FINAL ORDER

REQUEST FOR WRITTEN APPROVAL TO USE CONSTRUCTION METHODS NOT INCLUDED IN OREGON ADMINISTRATIVE RULES 690-200 THROUGH 690-240

(2) Start Card Number(s)(for work to be done): 163956

- (7) Diagram showing the pertinent features of the proposed well design and construction:
(attach additional pages if needed)

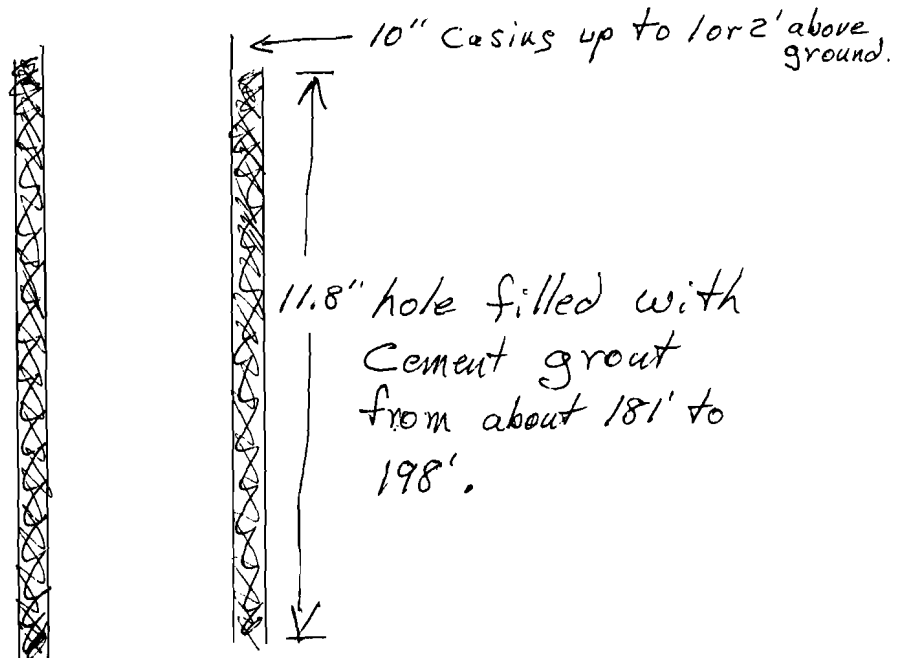
The special standard request you submitted for owner: Ron and Sue Johnston, start card number 163956 is approved for the following: reduced annulus in the lower seal (eccentric drilling), the lower seal shall be 15 feet, rather than the minimum 5 feet. See Oregon Administrative Rule (OAR) 690-210-0150. Your special standard request form is enclosed.

Pump in cement grout under pressure providing a 15 foot seal at a depth between 181' and 198'. Sealed in consolidated formation.
